## RESPONSE TO INFORMATION REQUEST

**COUNCIL REF: DA09/0701.03 LN35979**

**TSC SUBMISSION ALTITUDE ASPIRE RESIDENTIAL SUBDIVISION  
MP09/0166 MOD 3**

ALTITUDE ASPIRE TERRANORA  
LANDSCAPE MASTERPLAN STAGES 1-10

FIGURE 3 – CIRCULATION NETWORK

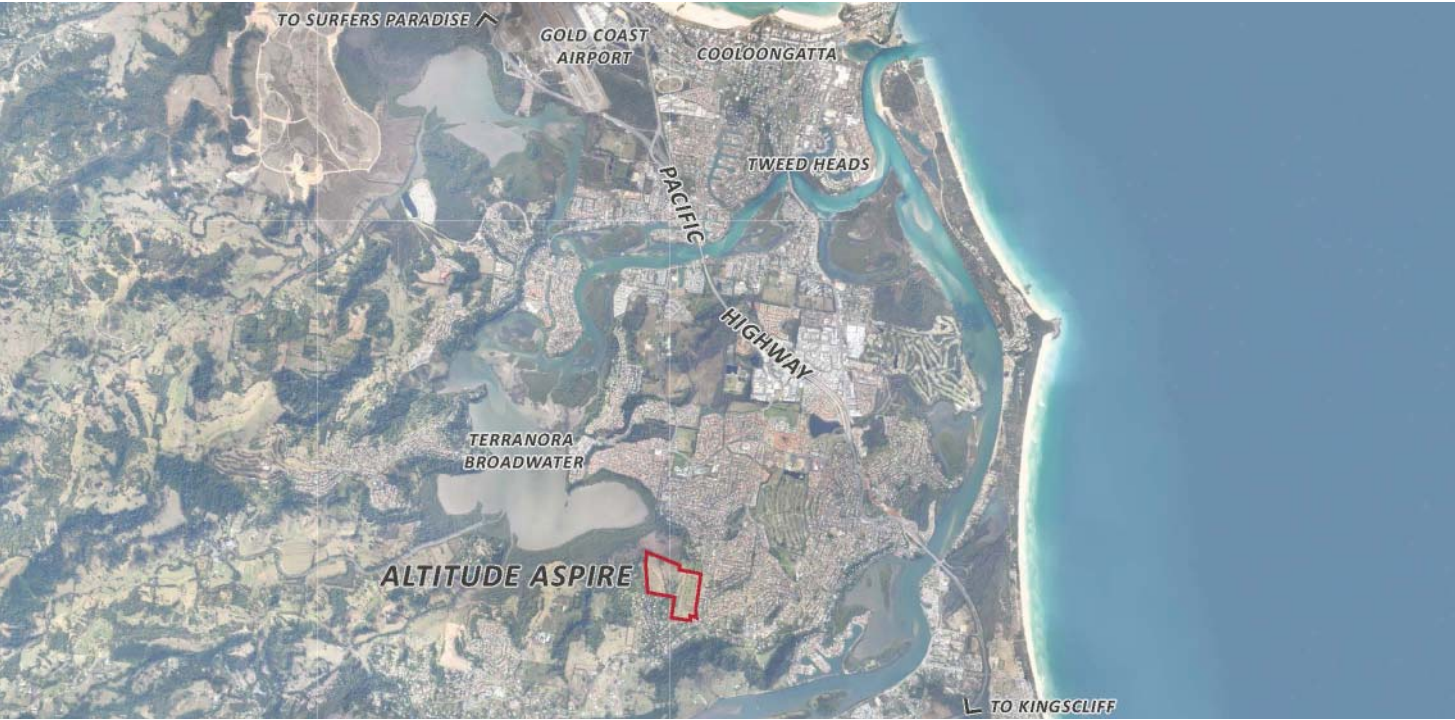
*v. Ensure there is adequate access for maintenance, particularly for maintenance vehicles.*

Adequate access is provided throughout the drainage reserve as indicated on the circulation network diagram shown on page 5. Note that pedestrian access is the only viable option along the drainage channel due to the size of rocks required to resist water velocities in peak storm events. Vehicle maintenance access is provided to the drainage channel at strategic points with space for turnarounds. Refer to the Civil Engineering response for more detail in regards to this matter.

FENCE TYPES & BALUSTRADES

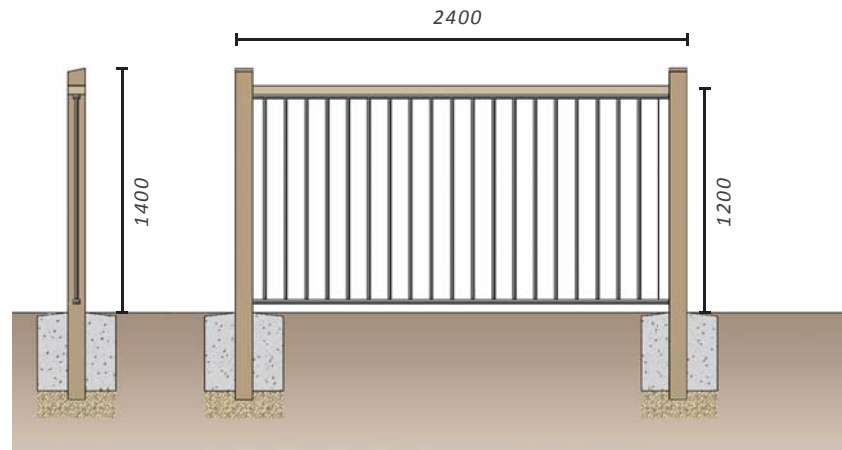
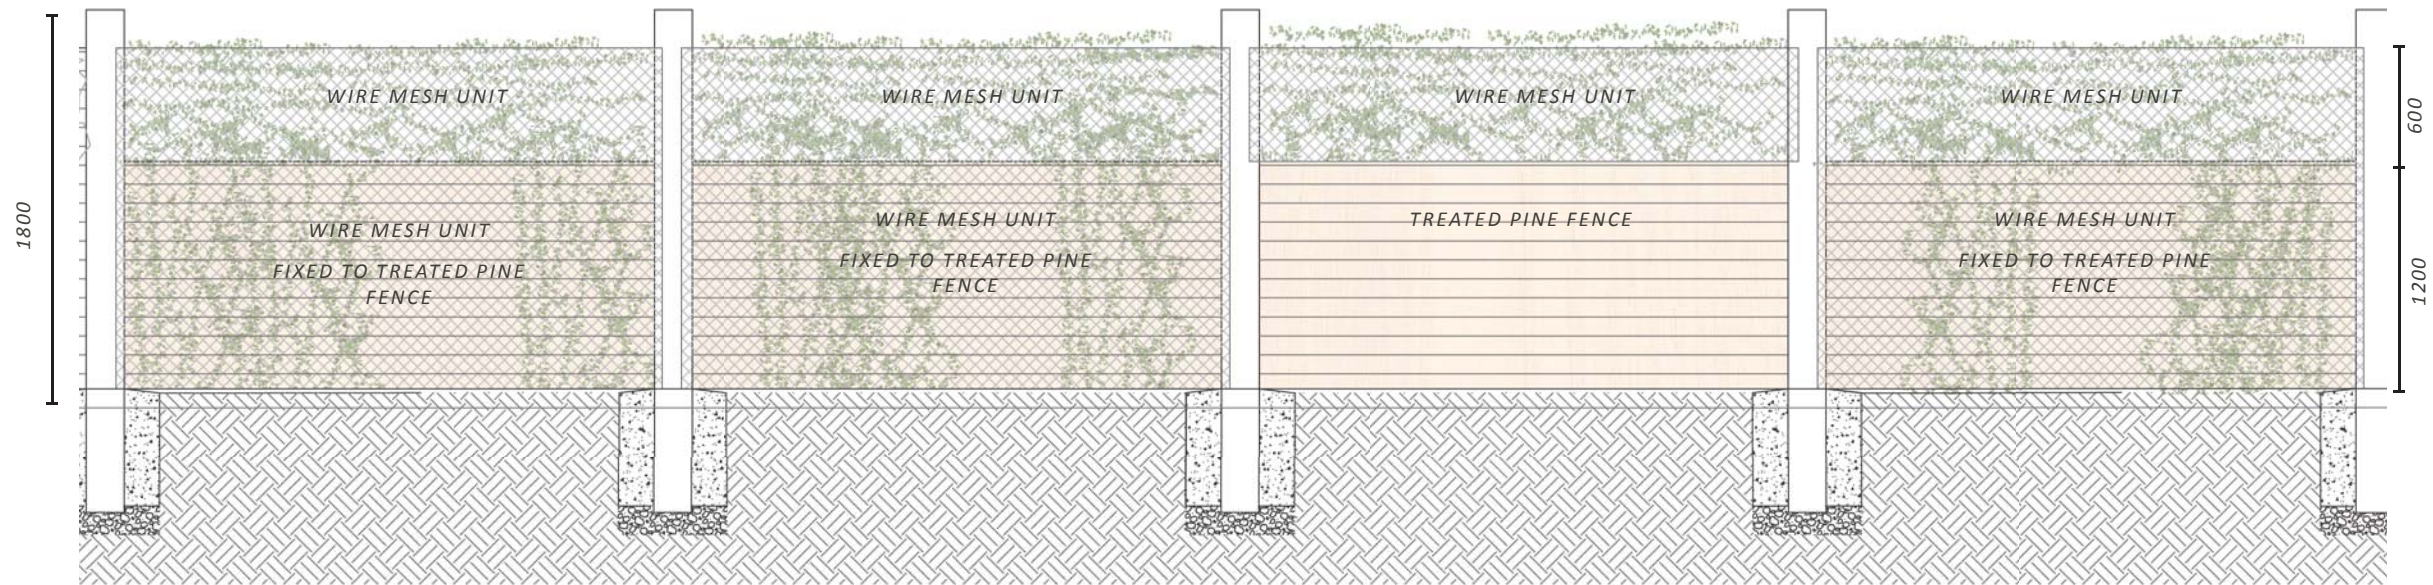
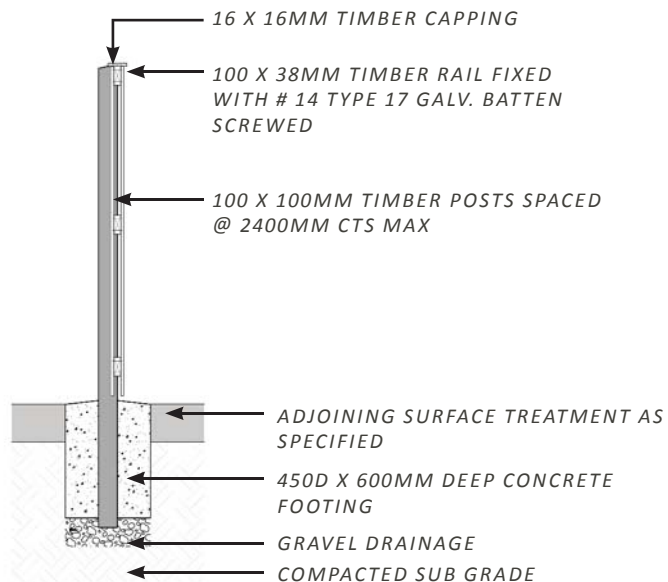
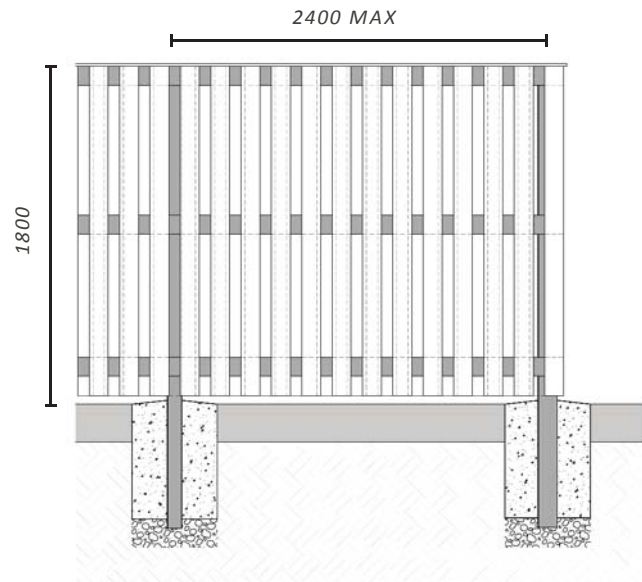
*j. If stairs are unavoidable, they are to be compliant with AS 1428 and all plans are to be annotated accordingly.*

Agreed, this level of detail will be provided through the Construction Certificate documentation phase.

## CENTRAL DRAINAGE RESERVE

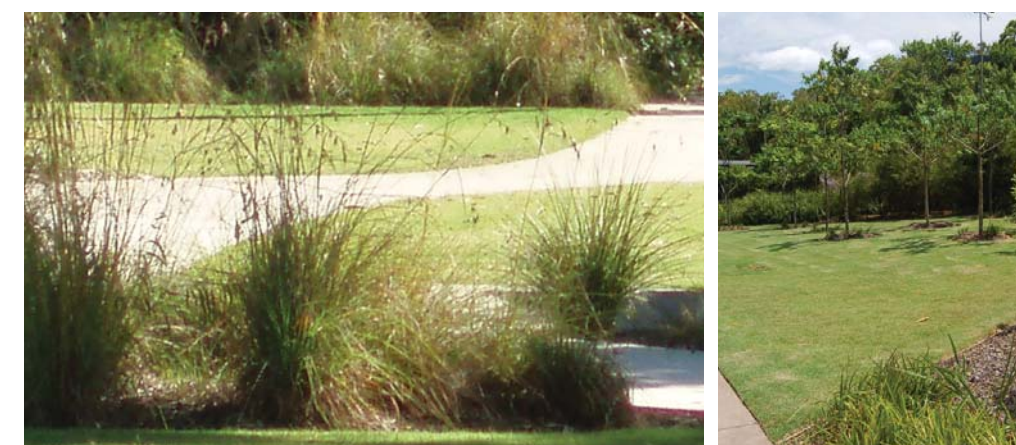
*g. Sheet 4: delete the 'Water Body / Frog Ponds' as they are not supported by TSC.*

*k. Sheet 12: the 'water body' is not supported and is to be deleted. Also delete the other minor 'water bodies' shown mid-site that are barely distinguishable.*

Water bodies and frog ponds have been deleted as requested.

This water body has been deleted as requested.
